Volume: XIX
Number: TC13-010
Date: 04/03/2013
 Action
 Retain
 Information

To: All Toyota Region/Private Distributor General Managers/Vice Presidents
From: Bob Waltz, 
Vice President, Product Quality and Service Support
Subject: **Owner's Manual Update**
2008 through 2012 Model Year Highlander and Highlander Hybrid Vehicles

PRODUCT UPDATE
Owner's Manual Update

Due to an administrative error, the tire pressure to optimize ride comfort, tire wear and vehicle performance *when towing* was not correctly reflected in the Owner's Manual.

Sample Owner's Manual Back Cover

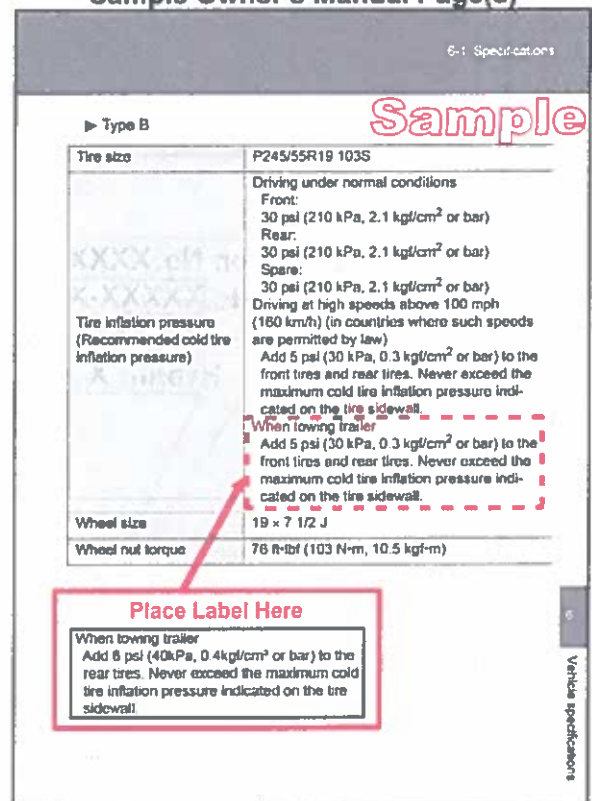
Model	MY	Part Number	Printed in Japan	Pages Requiring Label	
	<div style="border: 1px solid black; padding: 5px;"> When towing trailer Add 6 psi (40kPa, 0.4kgf/cm² or bar) to the rear tires. Never exceed the maximum cold tire inflation pressure indicated on the tire sidewall. </div>	Highlander	2008	01999-48690	--	p. 535
01999-48851				--	p. 539	p. 541
2009			01999-48834	--	p. 553	p. 555
			01999-48853	--	p. 563	p. 565
			01999-48A50	--	p. 563	p. 565
2010			01999-48A59	--	p. 570	p. 572
			01999-48B60	--	p. 574	p. 576
			01999-48815	--	p. 552	p. 554
2011			--	01-1008-00	p. 564	p. 565
			--	02-1008-01	p. 565*	
			--	03-1011-02	p. 565*	
			--	04-1101-03	p. 565*	
			--	05-1102-04	p. 565*	
2012			01999-48D00	--	p. 585	
			01999-48A09**	--	--

Sample Owner's Manual Back Cover

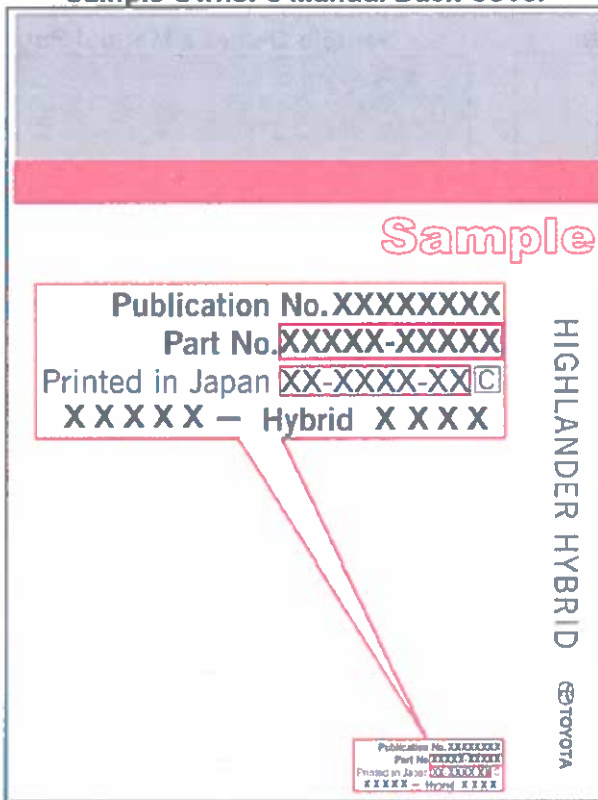
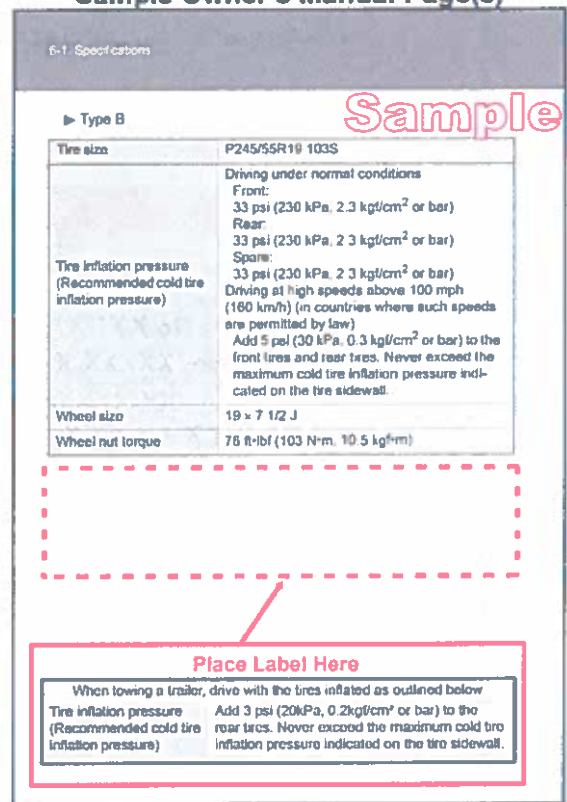
<p>When towing a trailer, drive with the tires inflated as outlined below: The inflation pressure Add 3 psi (20kPa, 0.2kgf/cm² or bar) to the rear tires. Never exceed the maximum cold tire inflation pressure indicated on the tire sidewall. (Recommended cold tire inflation pressure)</p>	Model	MY	Part Number	Printed in Japan	Pages Requiring Label		
	Highlander Hybrid	2008	ALL	—	—	p. 540	p. 542
		2009	ALL	—	—	p. 548	p. 550
		2010	ALL	—	—	p. 550	p. 552
		2011	—	01-1008-00	p. 564	p. 566	
			—	02-1009-01	p. 566*		
			—	03-1105-02	p. 566*		
	2012	—	01999-48D03	p. 582			
		—	01999-48A10**	—

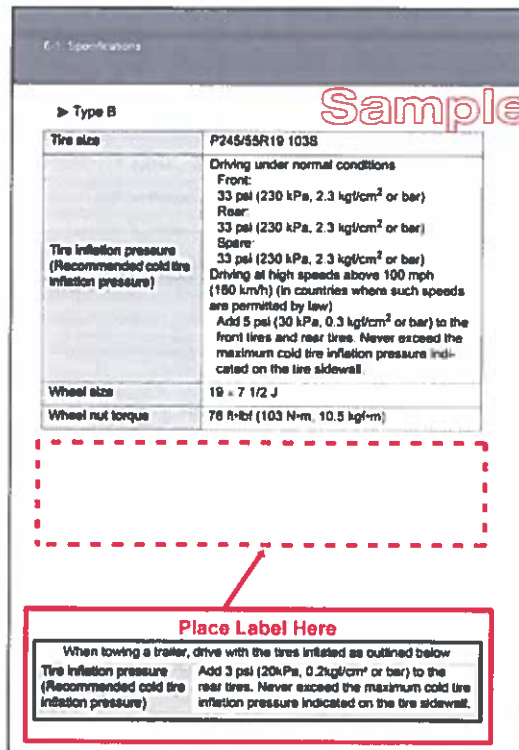
2. Place the enclosed update label(s), as shown in the figure below, on the page(s) (as indicated in step 1) of your Owner's Manual.

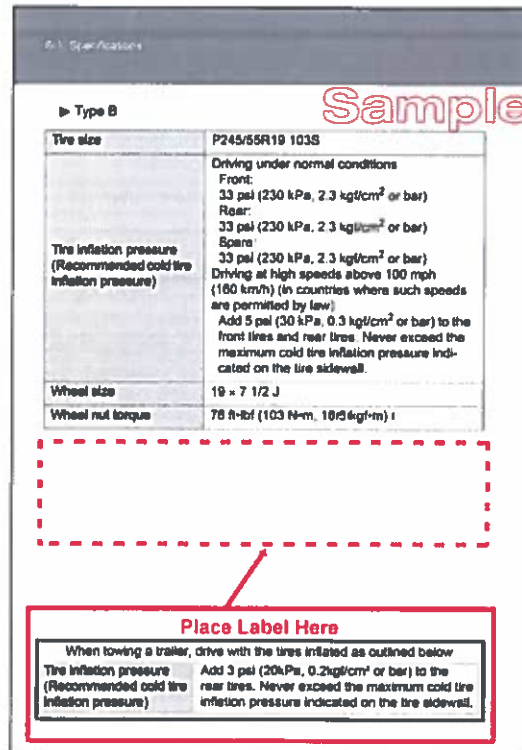
2. If the part number is 01999-48D03 place the update label, as shown in the figure below, on page 582 of your Owner's Manual.

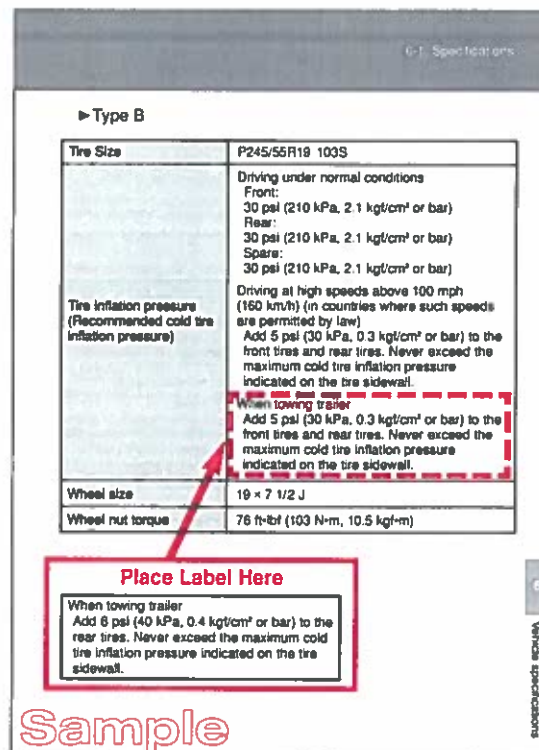
2. Place the enclosed update labels, as shown in the figure below, on the appropriate pages (as indicated in step 1) of your Owner's Manual.

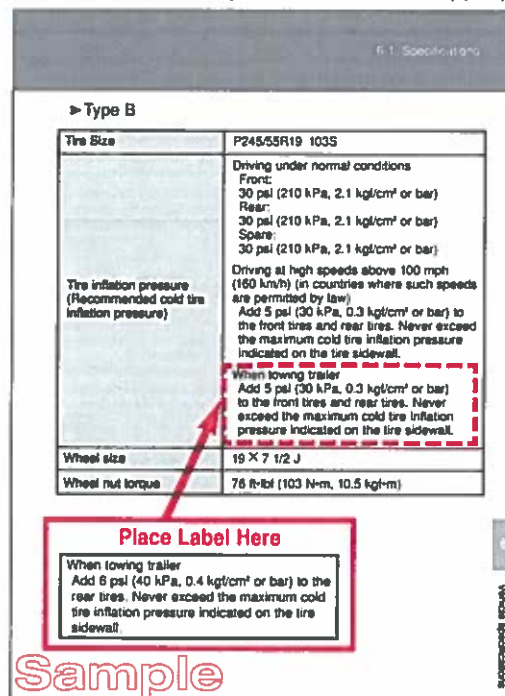
2. Place the enclosed update label(s), as shown in the figure below, on the appropriate page(s) (as indicated in step 1) of your Owner's Manual.

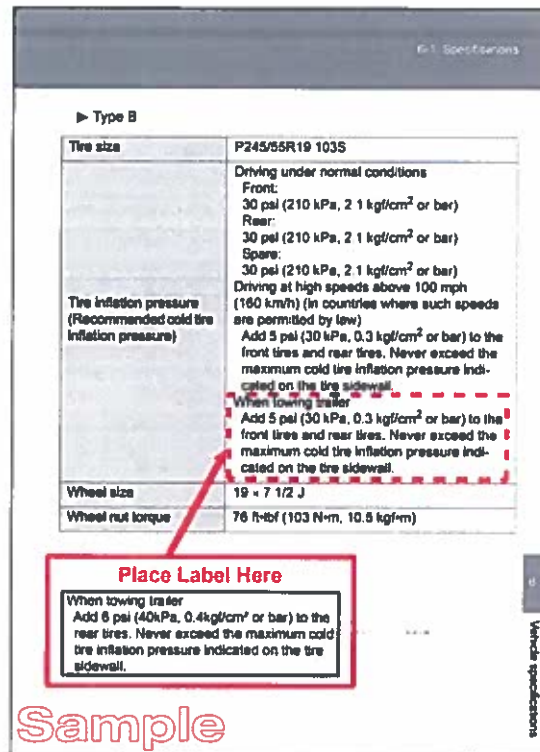
2. Place the enclosed update label, as shown in the figure below, on the appropriate page (as indicated in step 1) of your Owner's Manual.

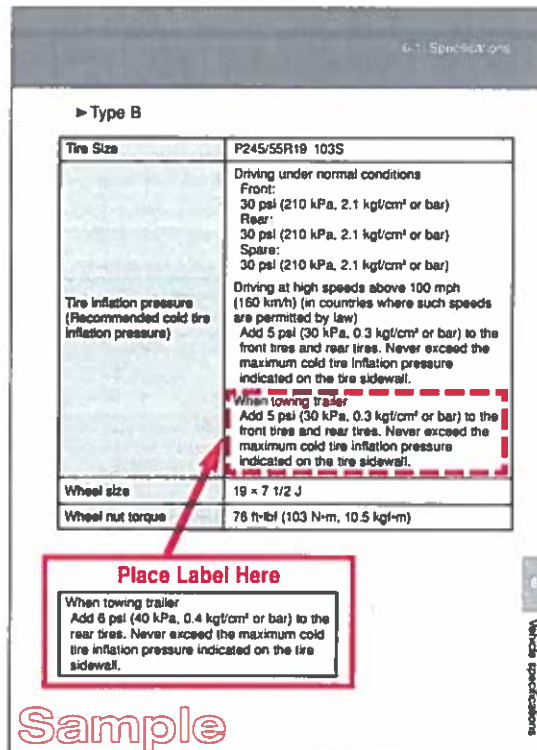
2. Place the enclosed update labels, as shown below, on the appropriate pages (as indicated in step 1) of your Owner's Manual.

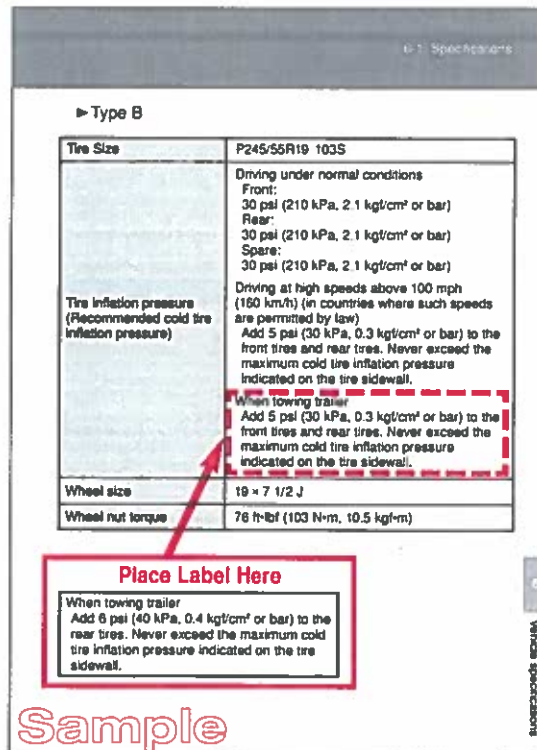
2. Place the enclosed update labels, as shown in the figure below, on the appropriate pages (as indicated in step 1) of your Owner's Manual.
